SIMMONS PARK ADDITION

Re: S/D 98-1 -- Final Plat of SIMMONS PARK ADDITION

Re: S/D 98-1 -- Final Plat of SIMMONS PARK ADDITION

CASE NUMBER: S/D 98-1 - SIMMONS PARK ADDITION

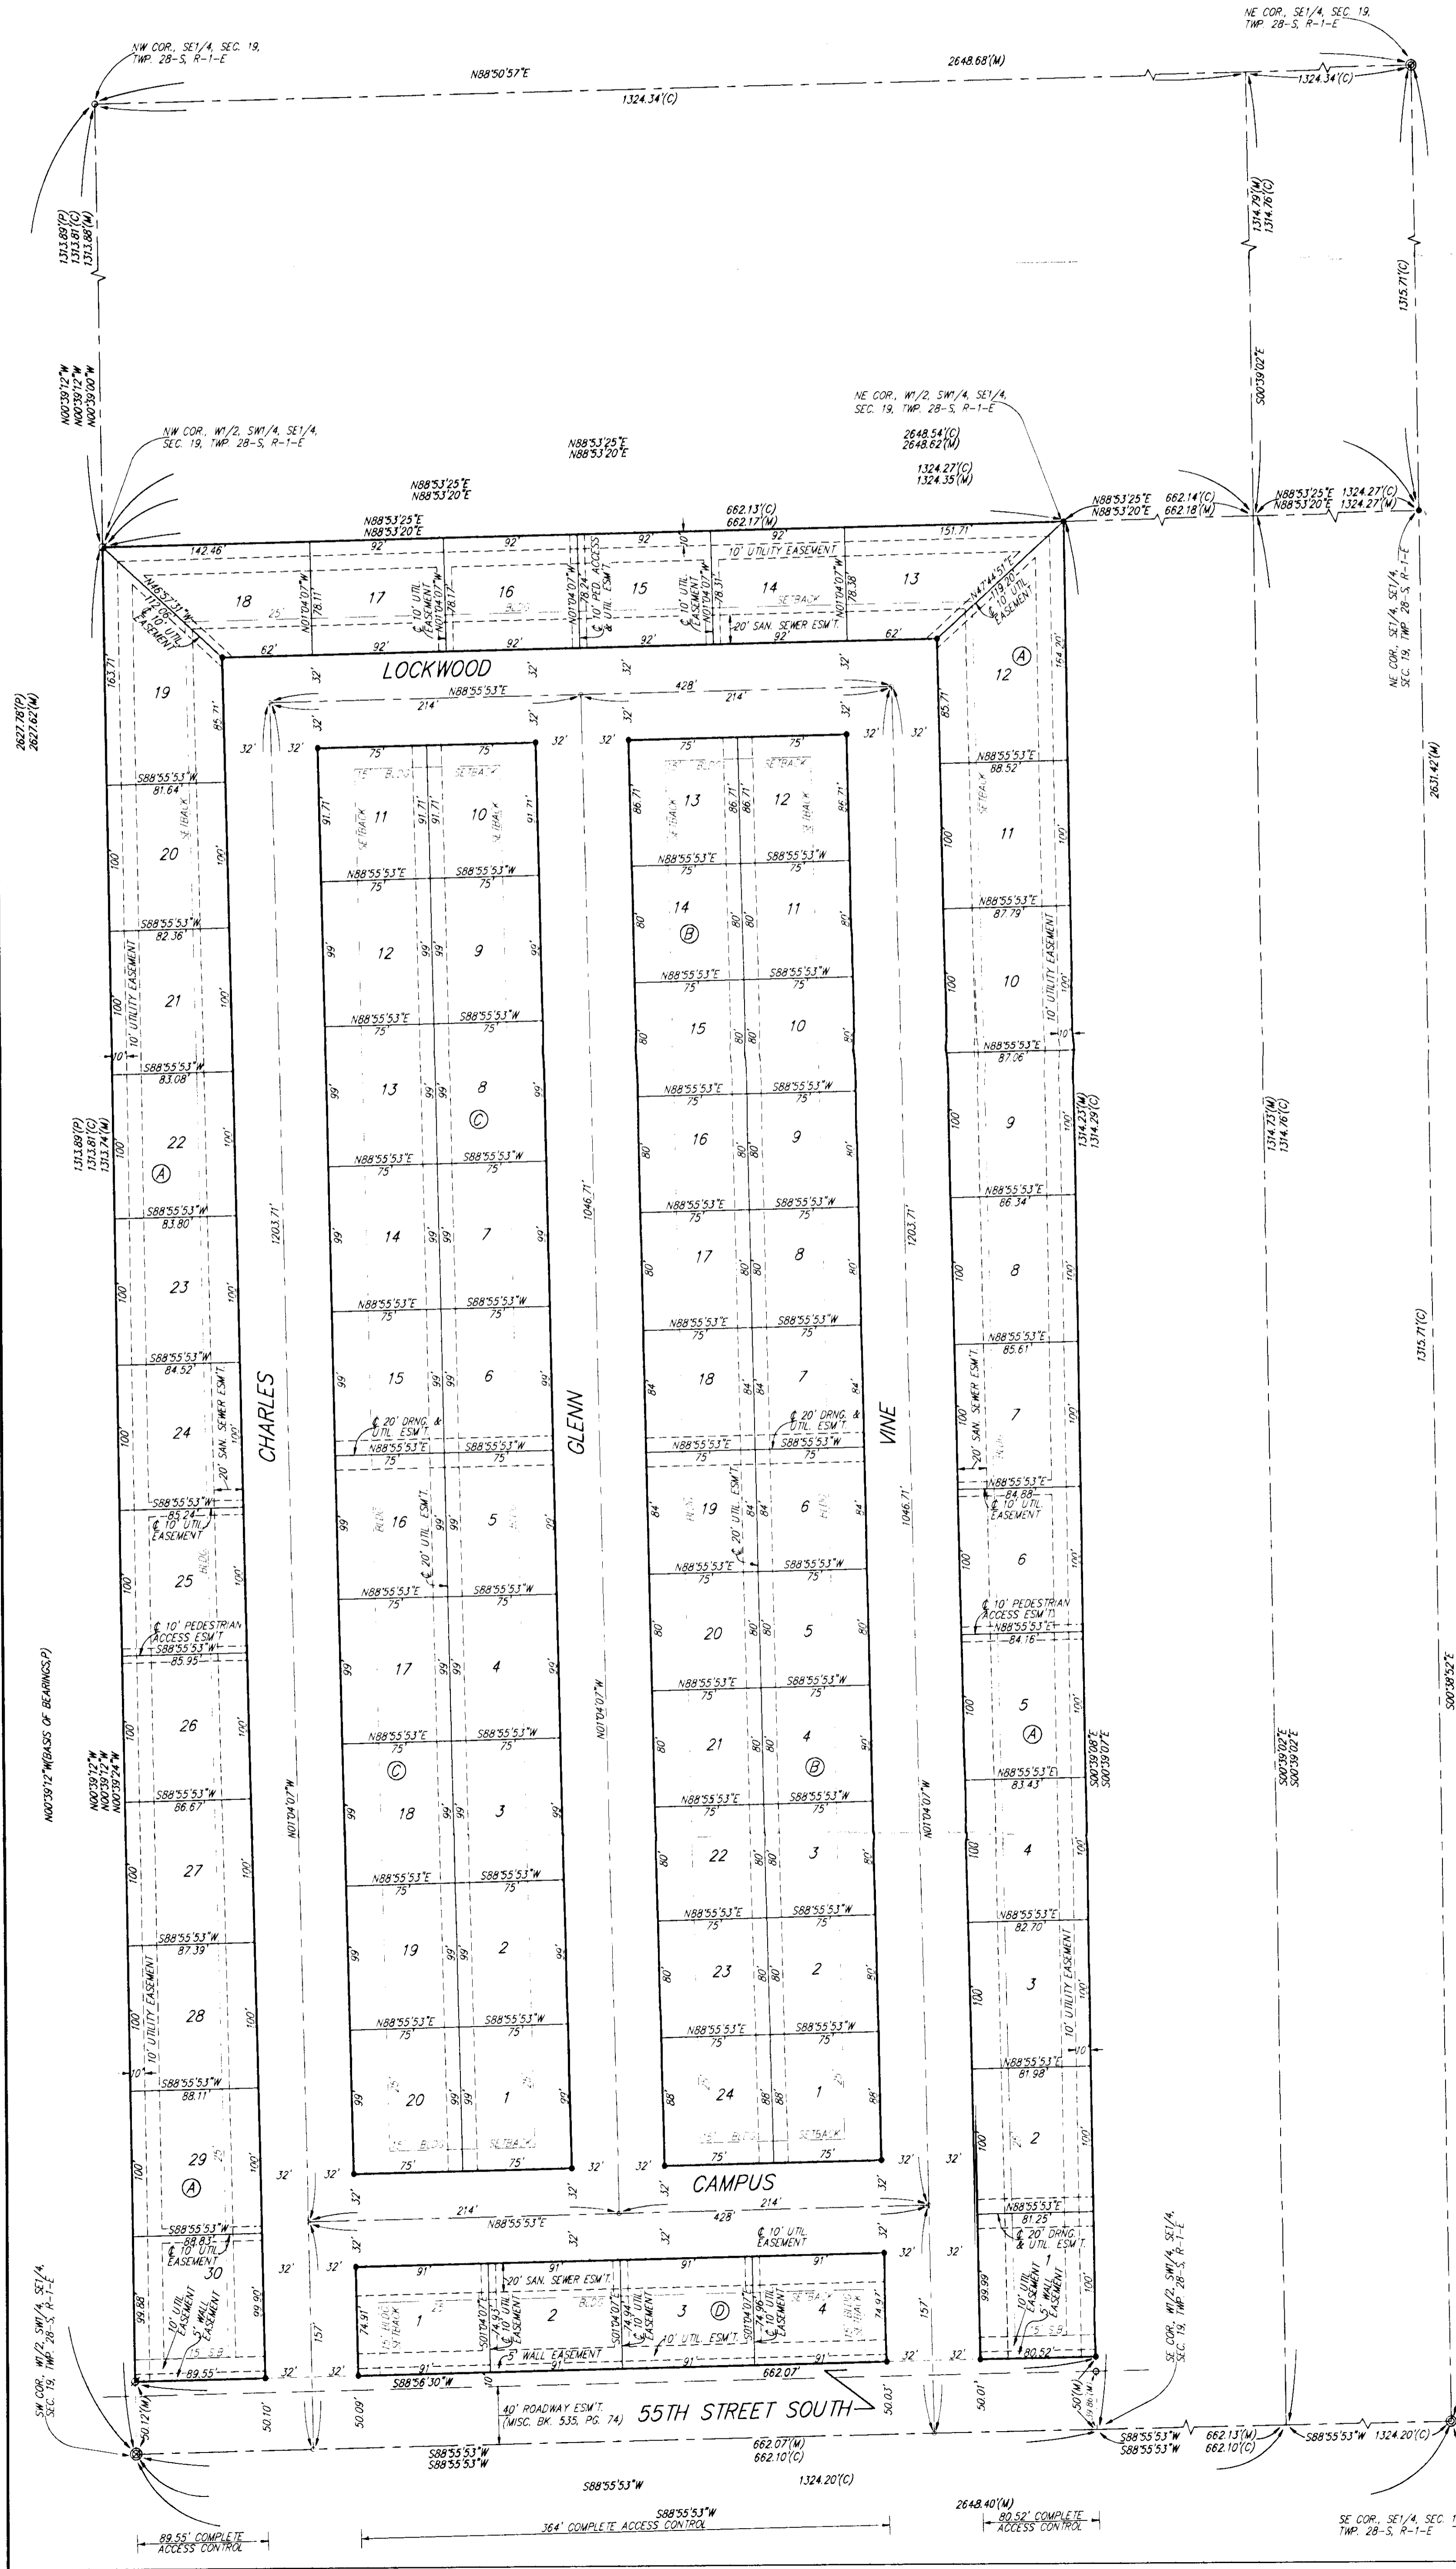
- C. 16 lots in Block B (containing 79 feet in width) do not meet the 6,000 sq. ft. minimum lot area standard and will need to be increased in width to at least 80 feet. It is recommended that all of the lots in the plat be increased in depth to at least 100 feet to allow for sufficient buildable area. **The Subdivision Committee approved the plat subject to the 16 lots being increased in size to 6,000 square feet.**

- F. It is recommended that the front yard utility easements for the perimeter lots are eliminated and overly wide utility easements (30 foot) be platted in the rear of these lots to allow for the installation of utilities without damage to existing tree rows. The depth of these lots should also be increased to allow for sufficient buildable area. **The Subdivision Committee**

approved the plat with the proposed front yard utility easements for sanitary sewer; as the applicant explained that sanitary sewer along the rear is unnecessary due to the lack of need for connection to adjoining properties.

- G. City Engineering needs to comment on the status of the applicant's drainage concept. The drainage concept is approved. An off-site drainage easement will be needed.

City Engineering needs to comment on the status of the applicant's drainage plan. The drainage plan is approved. Minimum building pad elevations are requested for the lots along the east line.

- I. On the final plat tracing, the platlor's text shall note that the access controls are being dedicated to the City of Wichita.

Easements requested by Southwestern Bell and KG&E are not being shown as was requested.

The front yard utility easements shall be relabelled sanitary sewer easements.
